Murray Basin Combined Sewer Overflow Project Community Advisory Group

Subject: Murray Basin CAG
Final Report and Recommendations

**Report and Recommendations
of Community Members of the CAG**

12 October 2010

COMMUNITY-SUGGESTED ALTERNATIVE 2-a
 STORAGE AT LINCOLN PARK LOWER PARKING LOT
 September 27, 2010

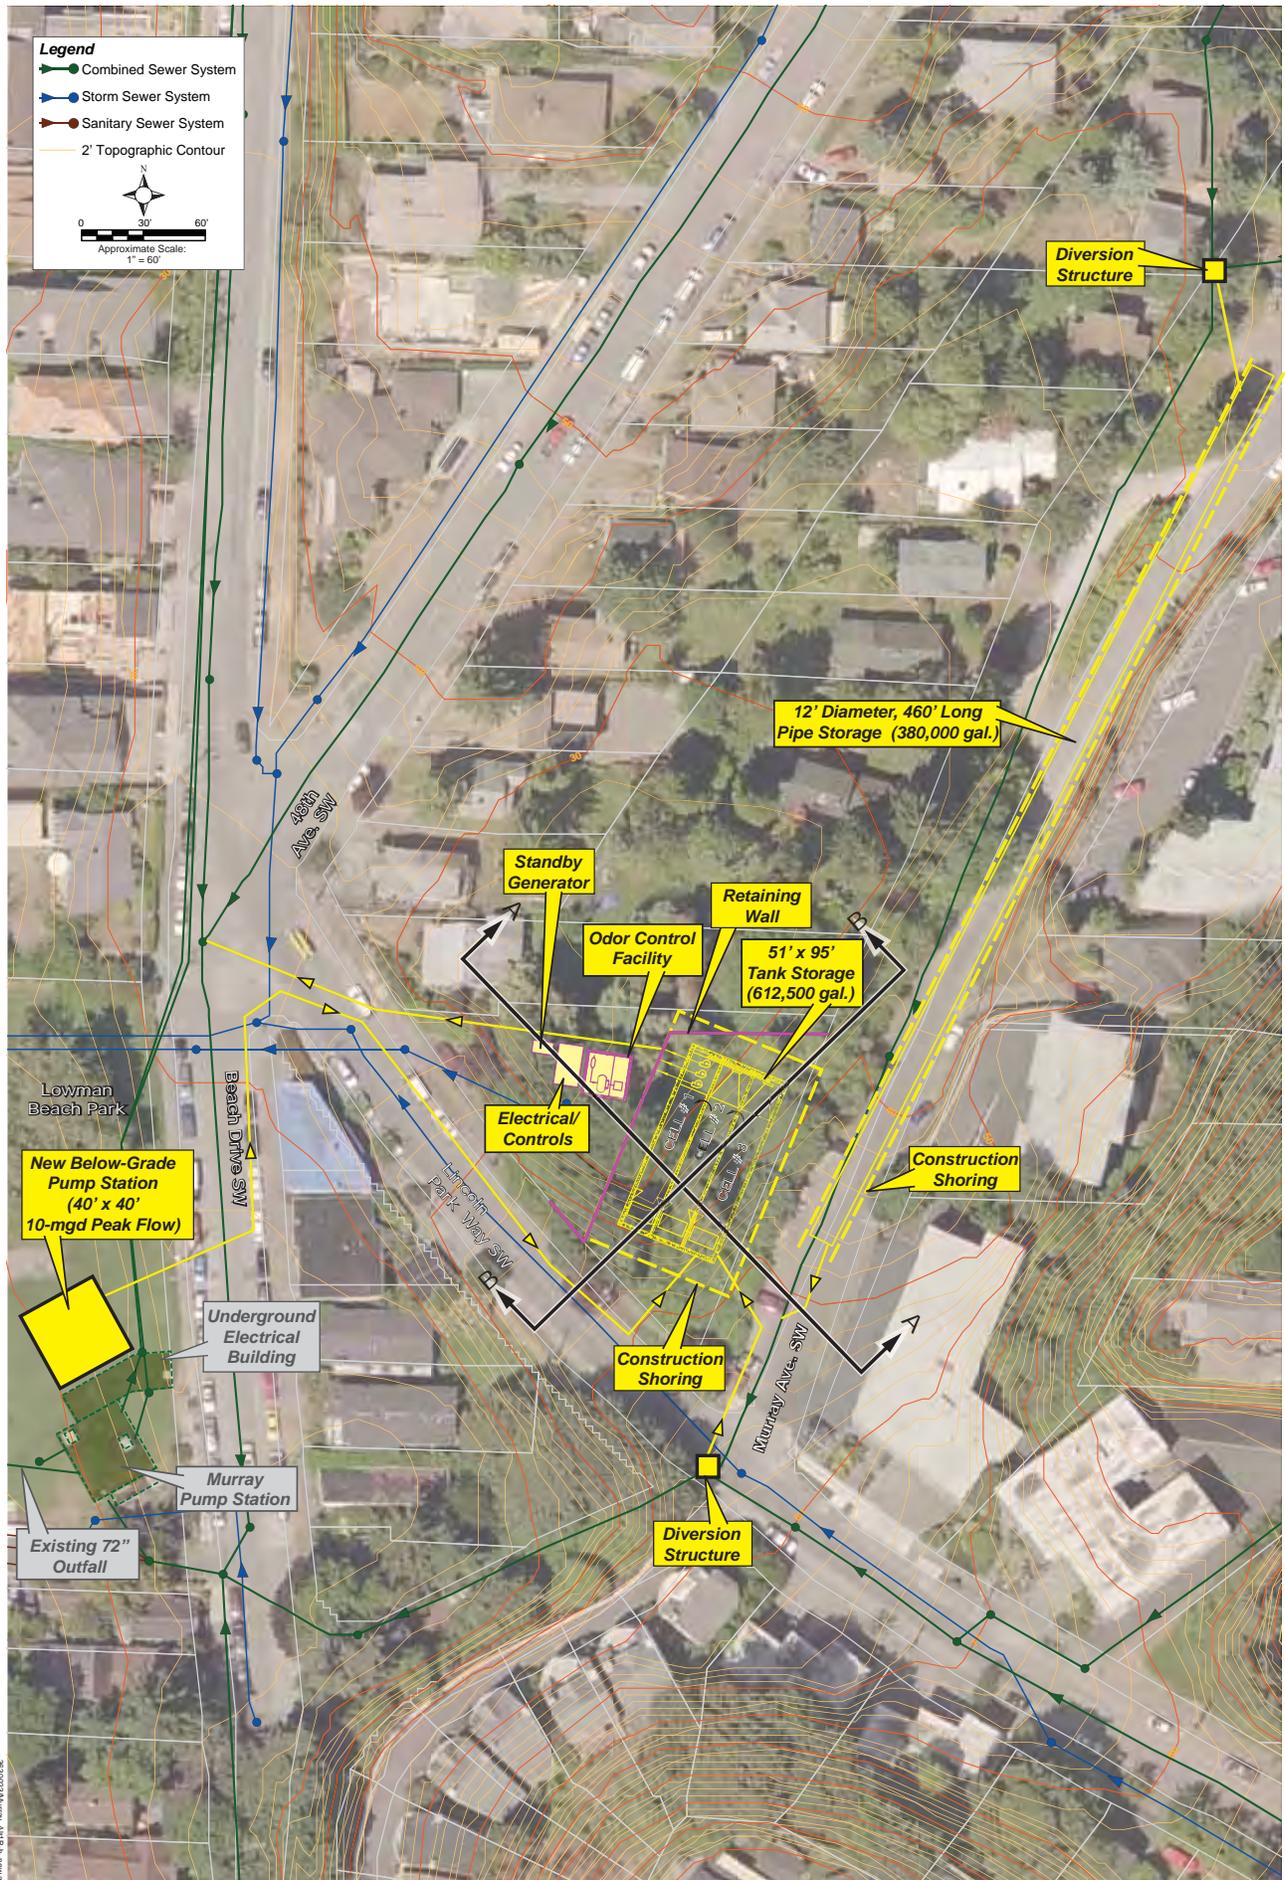
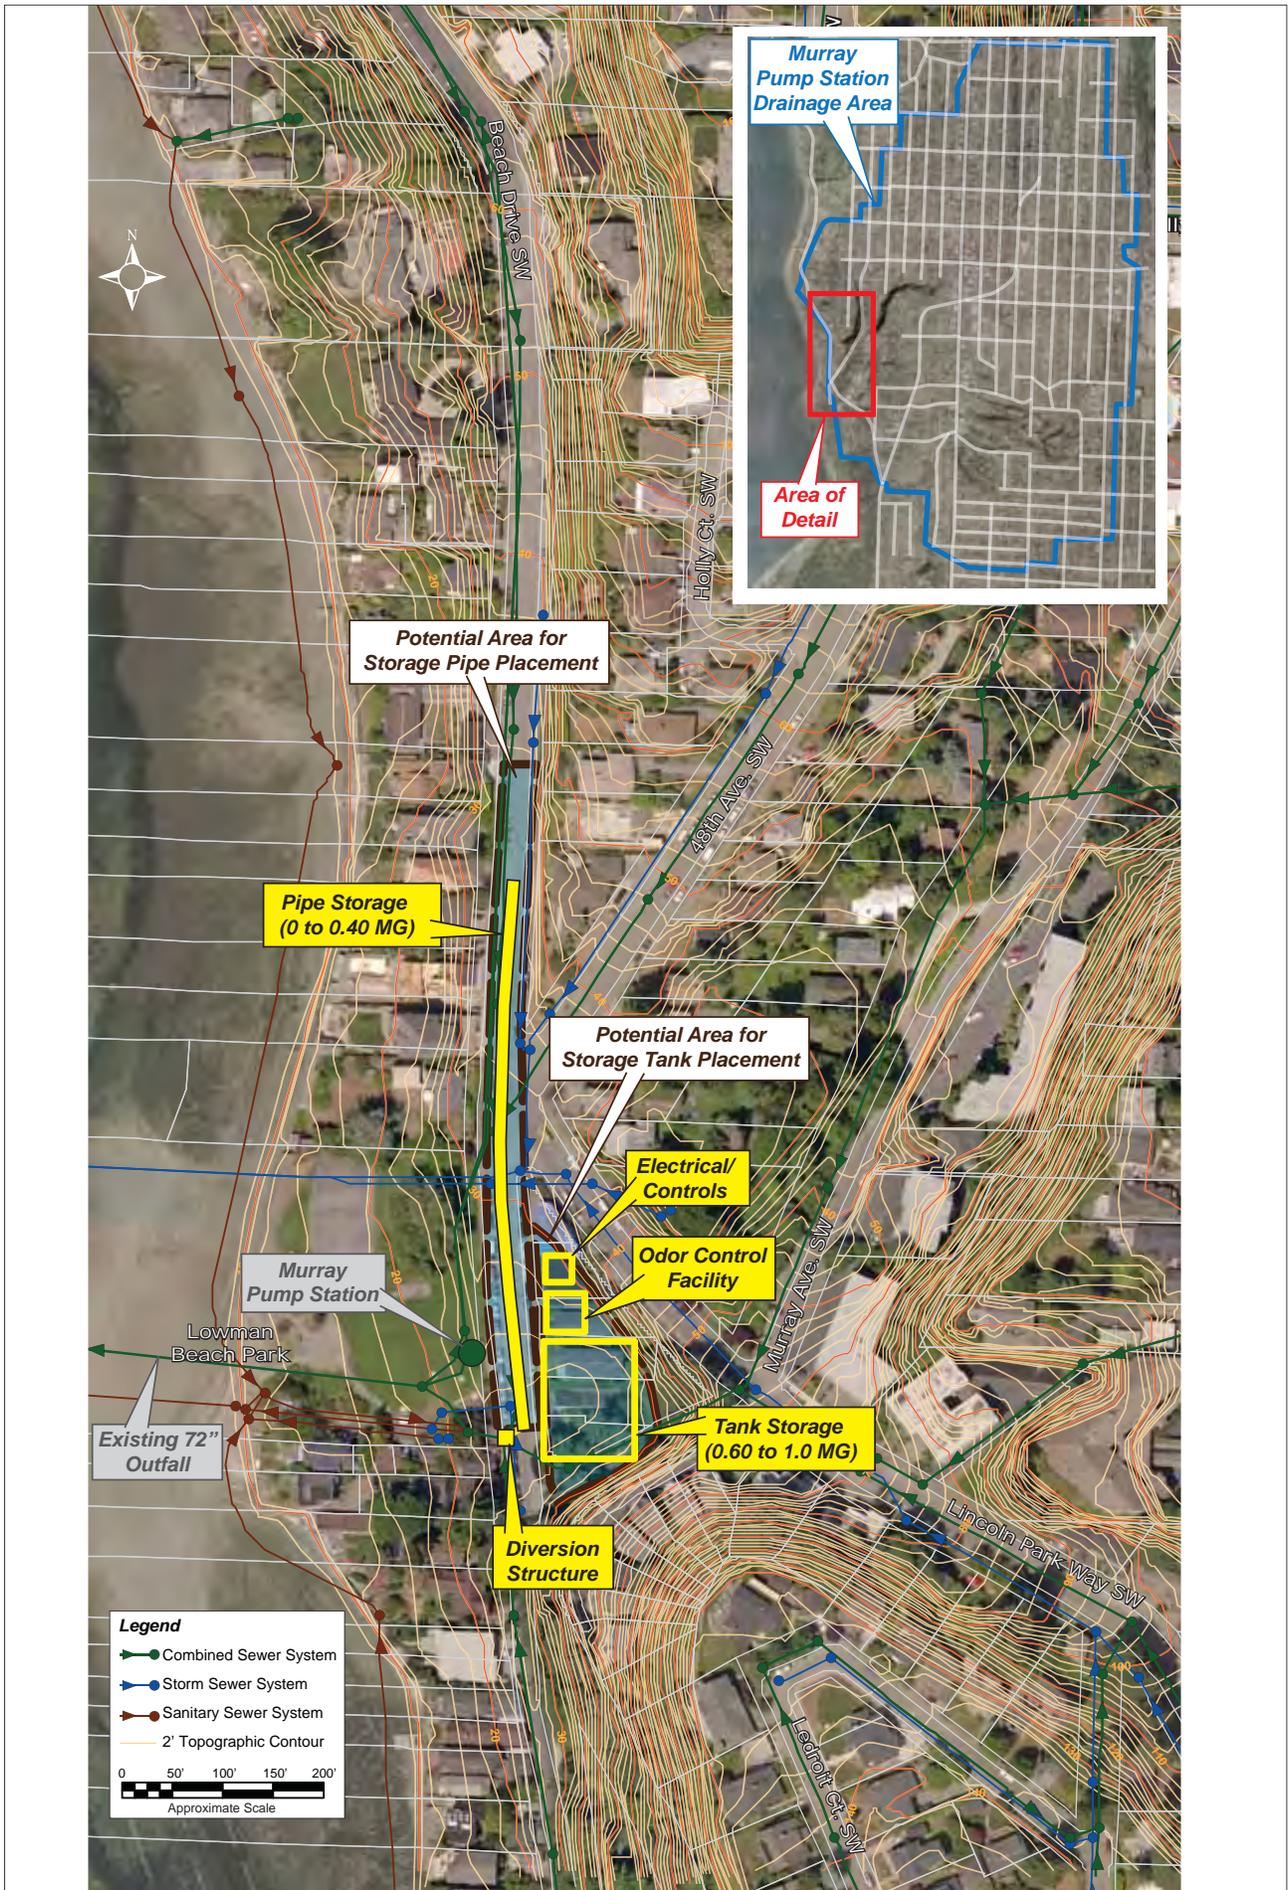
1. Advance CAG2a as the preferred alternative as modified for the 27 September 2010 CAG meeting.

This recommendation recognizes that a back-up alternative should be maintained pending confirmation of technical feasibility of CAG2a. It includes the proviso that a number of modifications should be incorporated into the alternative as currently drawn to further reduce the impacts on community, open spaces, wetlands and parks. They include:

- a. Increase storage at Fauntleroy School to 0.5mg in order to reduce the total storage requirement in Murray Basin to approximately 0.85MG.*
- b. Explore option to provide some additional upper basin storage (as shown in CAG8 Alternative) to further reduce required storage capacity in bottom of basin.*
